## ORIGINATION FORM

### Proposed Revisions to a Standard Plans Index (Please provide all information — Incomplete forms will be returned)

Index Number: 455-060

Index Title: 60" Prestressed Concrete Cylinder Pile

ELEVATION

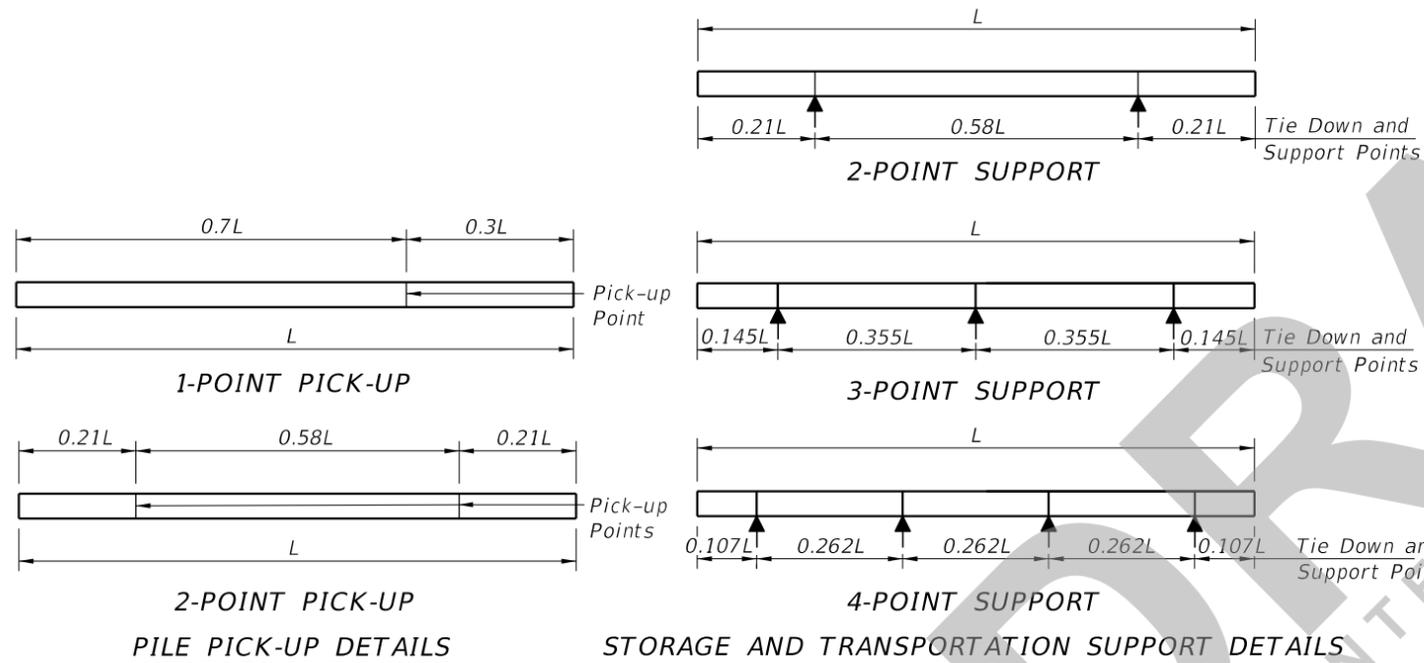
Change Silica Fume, metakaolin or ultra-fine flyash to Highly Reactive Pozzolans

Specification changed to fit silica fume, metakaolin and ultra-fine flyash under Highly Reactive Pozzolans

1. Work this Index with the Pile Data Table in the Structures Plans.
2. Concrete:
  - A. Piles: Class V (Special)
  - B. Splice Collar: Class IV
  - C. See "GENERAL NOTES" in the Structures Plans for locations where the use of Highly Reactive Pozzolans is required.
